Access Compliance Report

Public Rights-of-Way

Intersection ID: 2724	Main Street: CROWNISTA_DR	Cross Street: MORNINGSONG_LN	Location:	E
ADA ID: 5B266736D0BA	Ramp Type: PerpDiag	Initial Pass/Fail: Fail	Overall Compliance: No	Severity Score: 8.75
Codes/Mitigation Info/Possible Solution		Field Measurements/Component Compliance

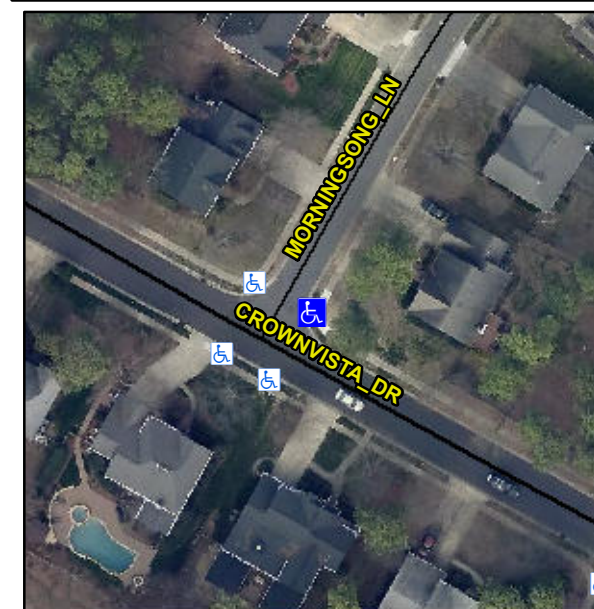
Not Found, R304.5.1

Compliance	Description	Data	Compliance	Description	Data
N/A	Ramp Length (in)	46.0	Yes	Ramp Slope (%)	8.3
No	Ramp Width (in)	38.0	Yes	Ramp XSlope (%)	0.3
N/A	Flare Type LT	N/A	N/A	Flare Type RT	N/A
N/A	Flare Slope LT (%)	N/A	N/A	Flare Slope RT (%)	N/A
N/A	Flare Traversable LT?	N/A	N/A	Flare Traversable RT?	N/A
N/A	Landing Length (in)	N/A	N/A	DWS Provided?	N/A
N/A	Landing Width (in)	N/A	N/A	DWS Contrast?	N/A
N/A	Landing Slope (%)	N/A	N/A	DWS Length (in)	N/A
N/A	Landing X Slope (%)	N/A	N/A	DWS Full Width?	N/A
N/A	Landing Curb? (Y/N)	N/A	N/A	DWS Offset (in)	N/A
N/A	Shared Landing?	N/A			
N/A	Gutter Ponding?	N/A	N/A	Gutter Slope (%)	N/A
N/A	Gutter Lip Ht (in)	N/A	N/A	Gutter X Slope (%)	N/A
N/A	Painted X Walk1?	No	N/A	Painted X Walk2?	No
	X Walk 1 Direction	To NW		X Walk 2 Direction	To SW
N/A	X Walk 1 Width (in)	N/A	N/A	X Walk 2 Width (in)	N/A
	X Walk 1 Slope (%)	3.6		X Walk 2 Slope (%)	0.7
	X Walk 1 X Slope (%)	0.0		X Walk 2 X Slope (%)	5.4

Remove & Replace Curb Ramp With Two New Directional Ramps or Equivalent.
